DEVELOPMENT FACILITATION TEAM (DFT) MEETING AGENDA

July 2, 2025

| Project No: PR-2020-003688 | Date: 7/02/2025 | Agenda Item: #11 | Zone Atlas Page: J-10 |

Application For: PA-2025-00184 - SKETCH

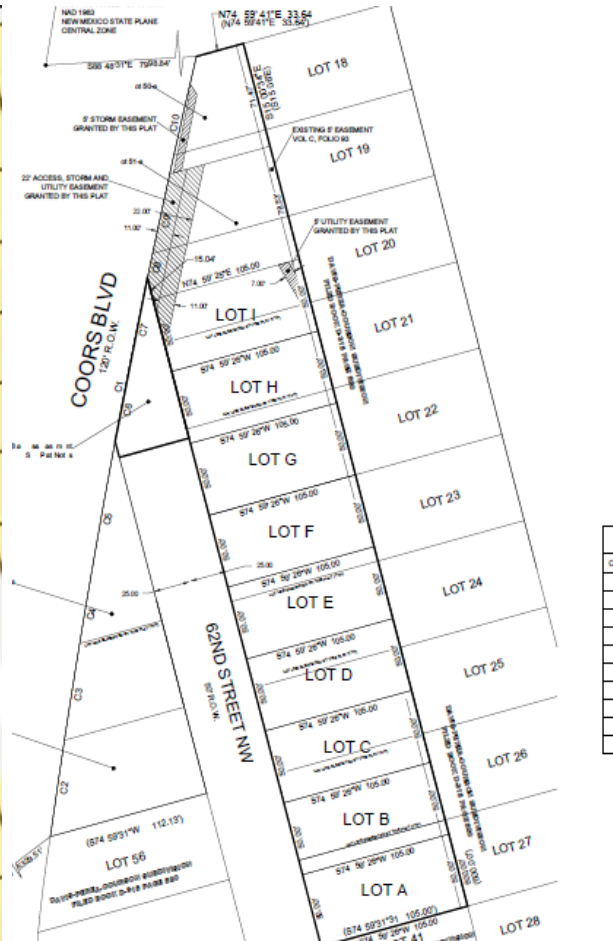
- This is a request for a Sketch Plat review to divide 10 recorded parcels into 13 lots along 62nd Street and Coors Blvd NW. of the Davis-Perea-Coursons Subdivision. The goal of this request is to be able to redistribute lot lines to accommodate thirteen residential lots and provide utilities for each lot. ***See exhibits below**

5-1(C)(2)(b) Lot Size

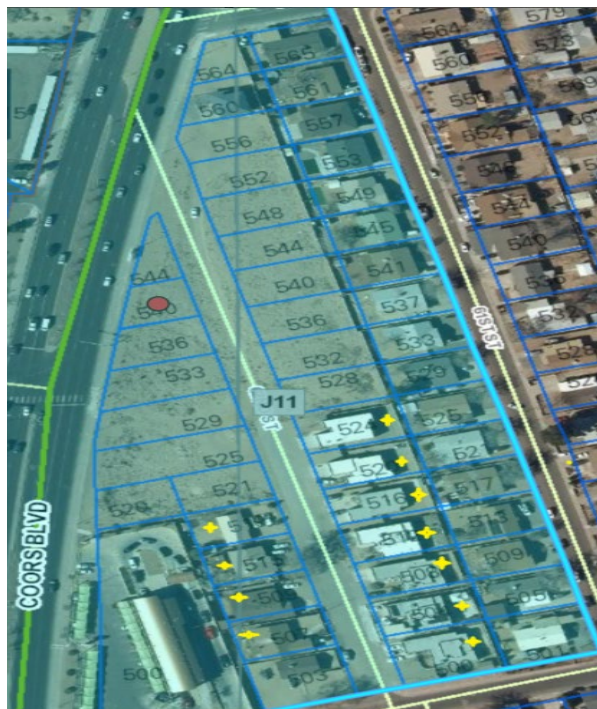
- Subject property is zoned R-1B, and is located within an Area of Consistency. It is therefore required to meet Dimensional Standards of IDO 5-1(C), Table 5-1-1 and, if applicable, the allowable Lot Size as per IDO 5-1(C)(2)(b), Contextual Residential Development in Areas of Consistency. **Planning staff defer to Code Enforcement for review of contextual lot size standards.**

- The calculations for these standards have been completed. The proposed lots now average 5,250 square-feet, which corresponds to a density of 0.1205 and meets the required standards. For reference, the average lot size in this area is 0.1483. Based on this, the allowable lot sizes for this area range from a minimum of 0.1112 to a maximum of 0.1854. **See exhibit below*
